# ETC® Release Note

## Eos®/ Ion™ Lighting Control Family Software

Version 1.4.0 software

500003895

### Key-Cap Update

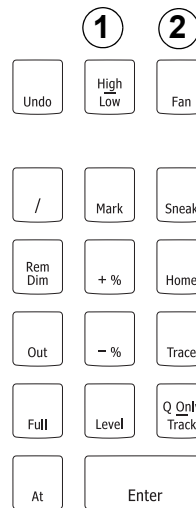
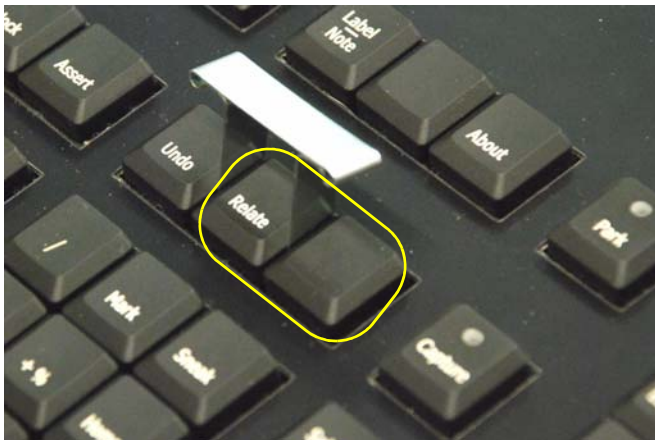
From Eos v1.3.1 to v1.4.0, two keys have been re-mapped and require that you change the physical keys on the console keyboard to match the software.

- Step 1: Use the key puller provided to remove the two keys shown below in the order indicated below.
- Step 2: Place the keys in their new correct locations and press them down firmly.
- “High/Low” replaces “Relate” and “Fan” replaces the blank key.

Below is the correct orientation to use the key puller for these keys. Remove “Relate” and the adjacent blank key.

Remove the keys in the order shown by the numbers next to each location.

This is the correct final position for the keys. “High/Low” replaces “Relate”. “Fan” replaces blank.
